Vermont Agency of Transportation  
**RECEIVED**  
 CK'D BY MEM OK'D BY CWC  
 Apr. 17, 2015  
 RESUBMIT APPROVED  
 BY C. Carlson DATE 04-20-2015

STRUCTURE: TH-8 (RIVER STREET) OVER OTTER CREEK  
BRIDGE NO: 2 (TH 8)  
RUTLAND CITY BRIDGE REPLACEMENT

LOCATION: RUTLAND CITY, VERMONT  
PROJ NO. BRF 3000 (16)  
CUSTOMER: KUBRICKY CONSTRUCTION CORP.

**INT. CROSSFRAMES**  
LOOKING UP-STATION  
72 REQ'D

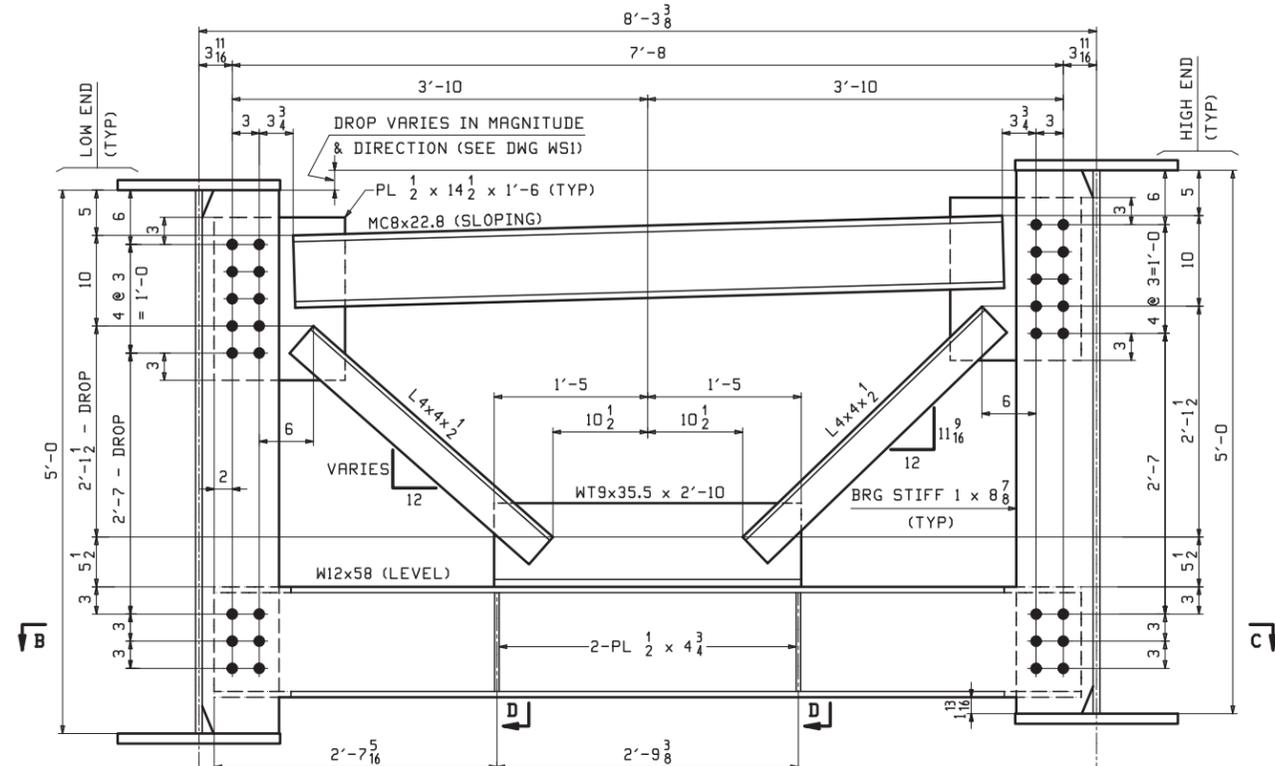
APPROVER NOTE:  
BOLT SPACING MODIFIED TO ACCOMODATE  
SEALING REQUIREMENTS (TYP).

**FIELD SPLICE DETAIL ~ XIM1**  
FIELD SPLICES 1 - AS SHOWN  
FIELD SPLICES 2 - ROTATE 180°

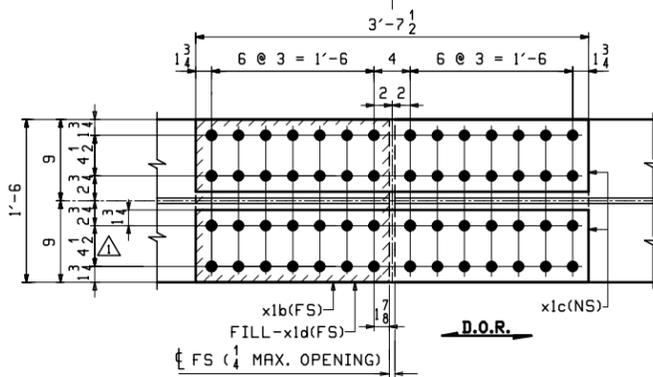
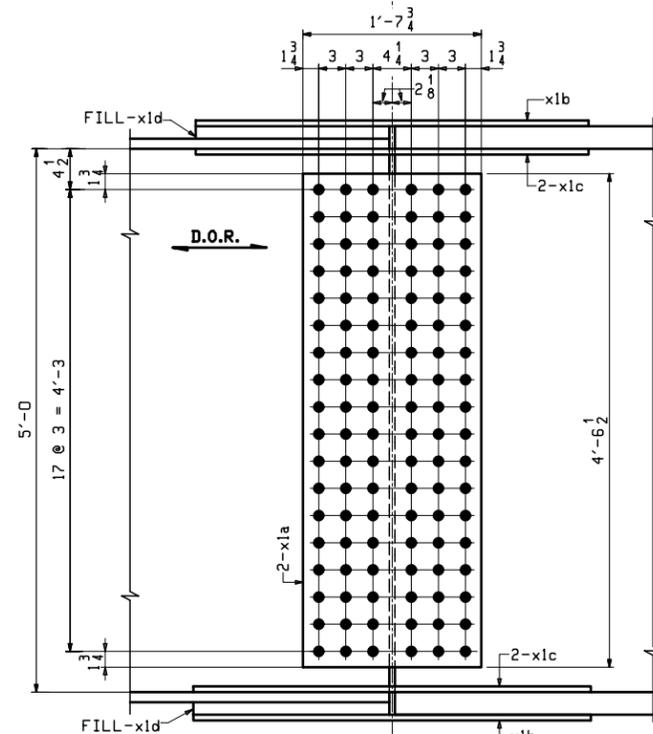
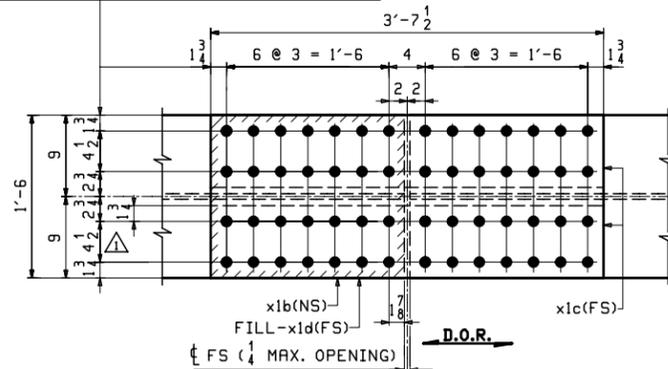
APPROVED: 1/13/15  
SPACING MODIFIED TO ALLOW FOR  
MINIMUM PREFERRED EDGE DISTANCE (TYP).

**ONE - GIRDER - 1G1A**

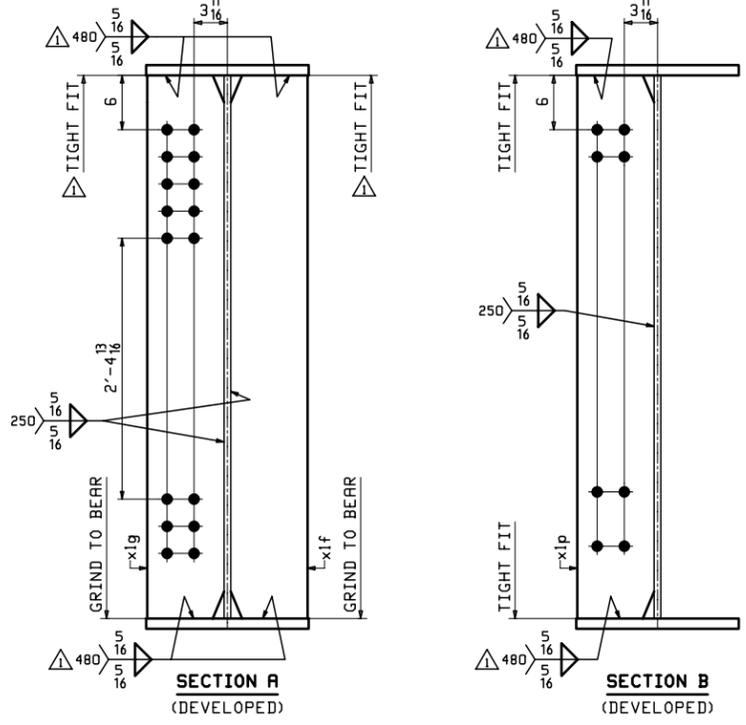
hole size and spacing for attaching 6" force main sewer line, invert to be 3'-2" above bottom of web

**ONE - GIRDER - 5G5A**

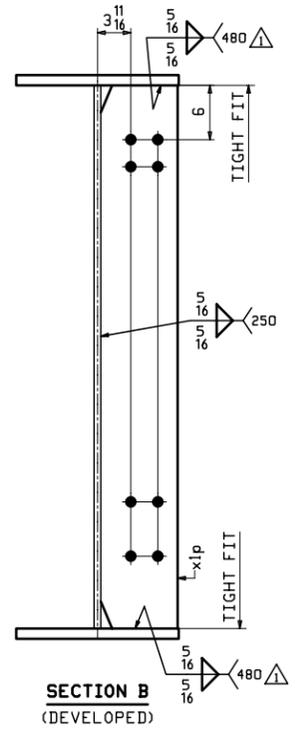
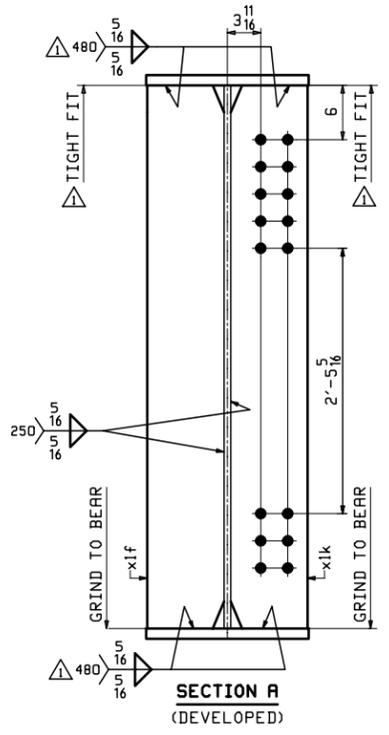
hole size and spacing for attaching 10" water line, invert to be 3'-2" above bottom of web

**ONE - GIRDER - 6G1B**  
 FOR GIRDER STANDARD DETAILS SEE DRAWING X1.  
 FOR CAMBER & FLANGE DIAGRAMS SEE DRAWING C2.  
 FOR GENERAL NOTES SEE DRAWING GNI.  
 T2 DENOTES MATERIAL SUBJECT TO CHARPY V-NOTCH TESTING.

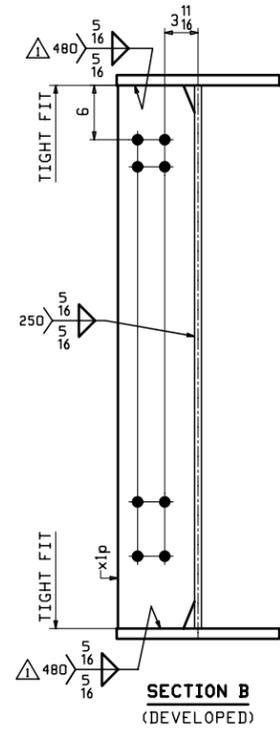
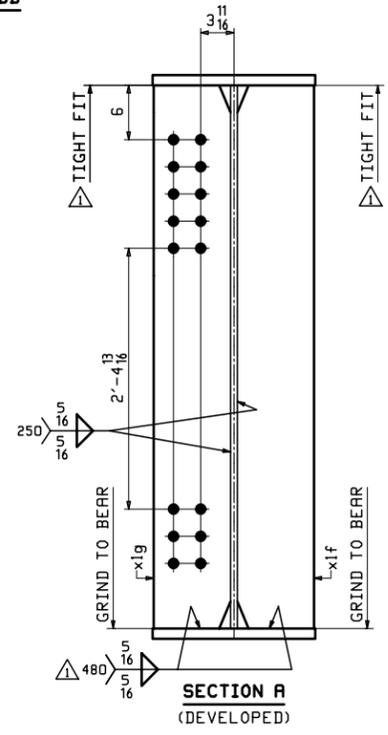
hole size and spacing for attaching 6" force main sewer line, invert to be 3'-2" above bottom of web

**ONE - GIRDER - 10G5B**  
 FOR GIRDER STANDARD DETAILS SEE DRAWING X1.  
 FOR CAMBER & FLANGE DIAGRAMS SEE DRAWING C2.  
 FOR GENERAL NOTES SEE DRAWING GNI.  
 T2 DENOTES MATERIAL SUBJECT TO CHARPY V-NOTCH TESTING.

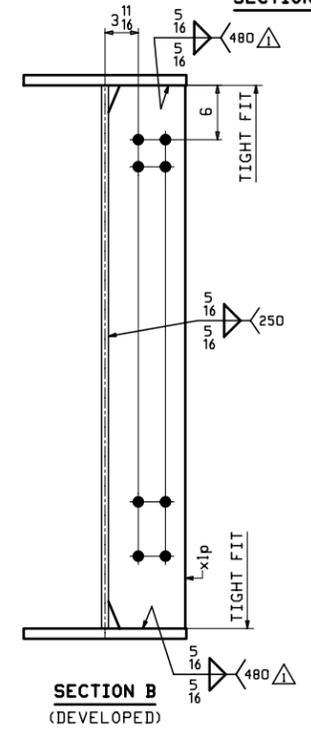
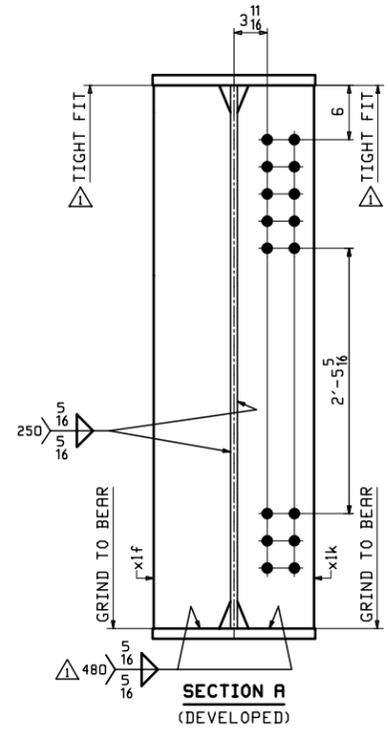
hole size and spacing for attaching 10" water line, invert to be 3'-2" above bottom of web

**ONE - GIRDER - 15G5C**

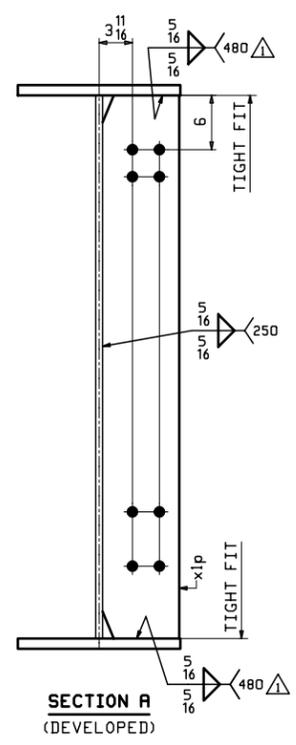
hole size and spacing for attaching 10" water line, invert to be 3'-2" above bottom of web
